DRAINAGE PROPOSAL

**Lots 2813 (Part), 2878 (Part) and 2879 (Part) in
D.D. 111 and Adjoining Government Land,**

Revision : B

Submission of Drainage Proposal

(b) Proposed Drainage Plan

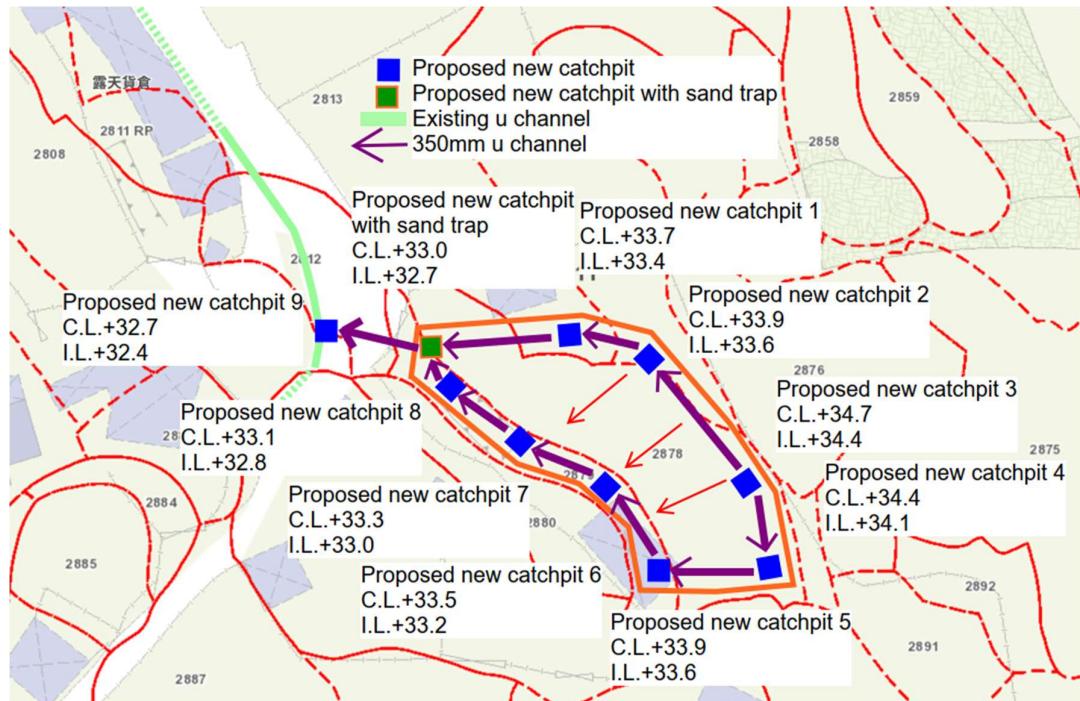
<u>Comments from Drainage Sewerage Department</u>	
<u>Comment</u>	<u>Responses</u>
(a) Please demonstrate the existing u-channels at discharge point is able to cater for the surface runoff discharged from the entire application site and overflow flow from the adjacent sites.	Noted and Revised

(d) Cross section of existing and proposed ground levels

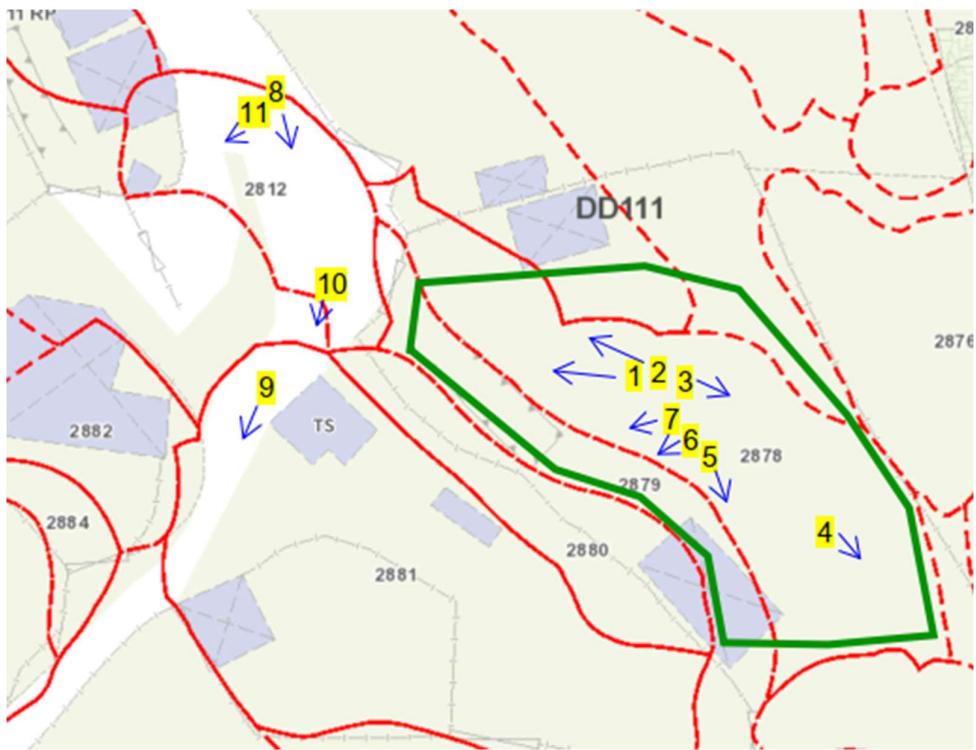
(b) Please indicate C.L., I.L and B.L. of all existing and proposed channel(s)/catchpit(s) in the section B1-B2.	Noted and Revised
(c) Colour photos to indicate the current conditions of the existing u-channels at discharge point and the proposed 350mm u-channel outside the application site should be included in the submission. The photos taken locations and angles should be shown on the layout plan.	Noted and Revised
